SIL 15-TR-12
January, 2013
Page 1 of 14

SUBJECT: Release of Allison Transmission 5th Generation Controls System

MODELS AFFECTED: Allison 1000, 2000, 3000, and 4000 Series Product Families

Figure 1. Allison 5th Generation Chassis-Mount TCM

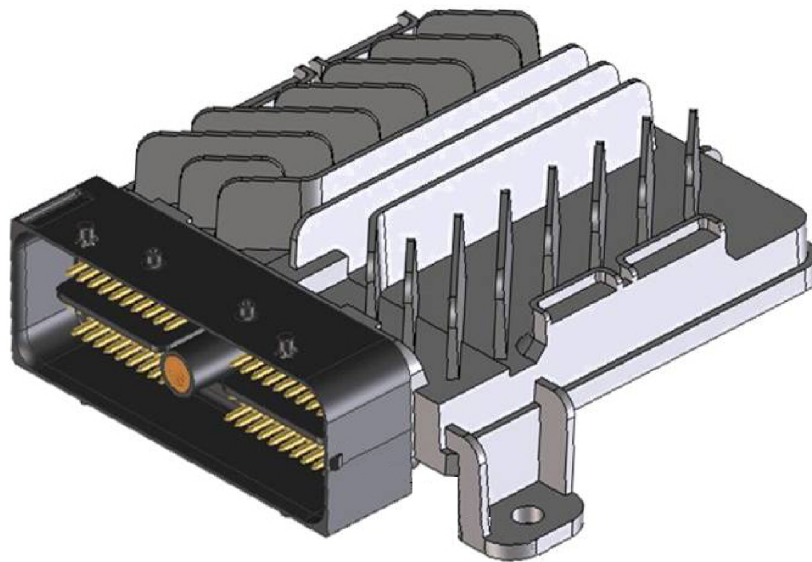
The Allison 5th Gen Controls System chassis-mount TCM physical design is common among all 1000/2000/3000/4000 Series Product Families transmissions. The 5th Gen TCM 80-way connector mates to the same 80-way OEM harness connector as the 4th Gen Controls System. The TCM has the same mounting features and space claim as the former 4th Gen TCM. The 5th Gen TCMs may be distinguished from 4th Gen TCMs by an all-metal case and shape of the heat sink (refer to [Figure 1](#)).

Figure 2. Typical 5th Gen Pushbutton Shift Selectors

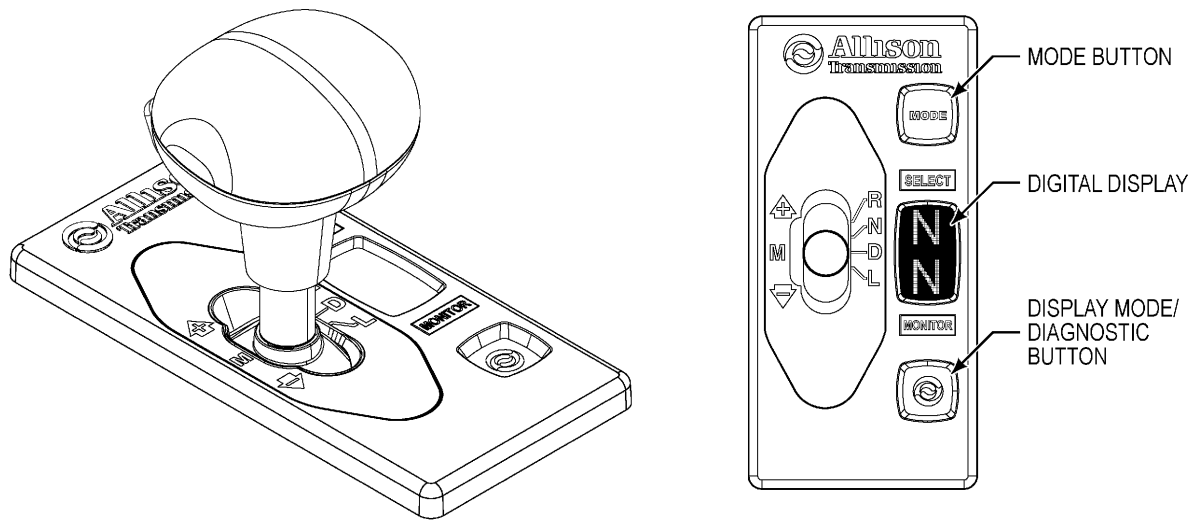
- **New Functionalities for Allison 5th Gen Controls**
 - Selection of the Mode Function is indicated on the graphical display instead of the keypad.
 - Shift Selector Displays change from Segmented Vacuum Fluorescent Display (VFD) to Graphic VFD.

- Strip Shift Selectors are now SAE J1939-based, and use the same 16-way connector as Pushbutton and Bump Lever Shift Selectors.
 - Pushbutton Shift Selector Arrows have “positive” (+) and “negative” (-) signs.

Figure 3. Typical 5th Gen Bump Lever Shift Selector

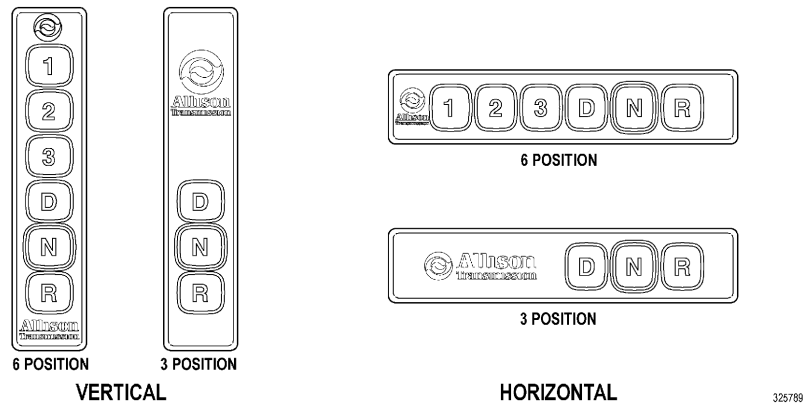
- Bump Lever Shift Selectors (BLSS) incorporate a modernized manual select feature that allows the operator to select a lower or higher forward gear range with a simple movement of the selector handle.
